Title: INDUSTRIAL TANK SUPPORT

Amendment Responsive to Office Action of September 3, 2004

1/6

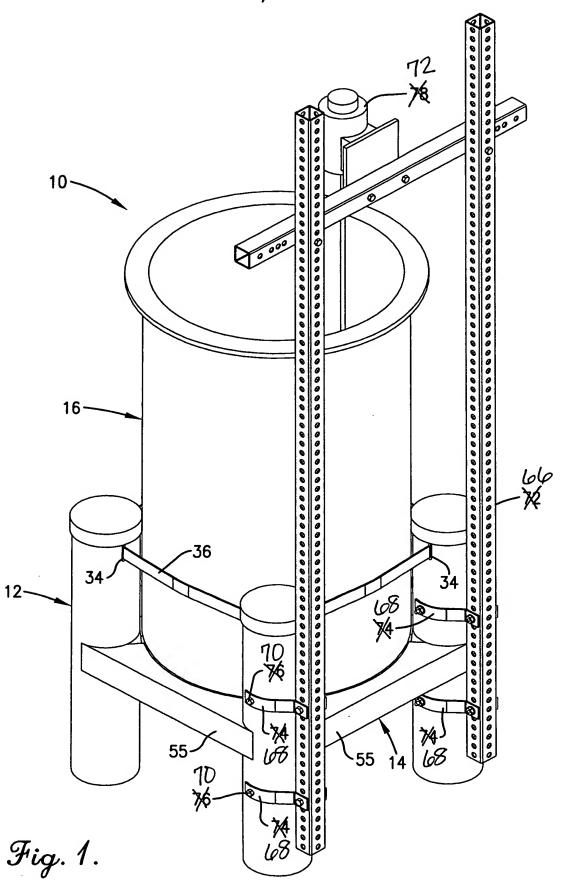
In the Office Action, the Examiner objected to the drawings as failing to comply with 37 C.F.R. § 1.84(p)(5) by not including in the specification the reference numerals 74, 76, and 78. Further, reference numerals 68 and 70 that were mentioned in the specification were not denoted on the drawings. Applicant has addressed the Examiner's objections by removing reference numerals 74, 76, and 78 from the drawings and adding reference numerals 66, 68, and 70 to Figure 1. Additionally, Applicant notes that reference numeral 24, which is discussed at page 4, lines 23 and 30 and page 15, line 15, was not denoted in Figure 4. Reference numeral 24 is to the sidewall of each leg, as discussed in the specification at page 4, line 23. Applicant has amended Figure 4 to now denote reference numeral 24. Annotated Marked-Up Sheets illustrating the drawings changes in red accompany this Amendment. Should the Applicant's amendments be acceptable to the Examiner, Applicant has also attached Replacement Sheets that are formalized.

Figure 1 - Replaced reference numeral 72 with reference numeral 66; replaced reference numeral 74 with reference numeral 68; replaced reference numeral 76 with reference numeral 70; and replaced reference numeral 78 with reference numeral 72.
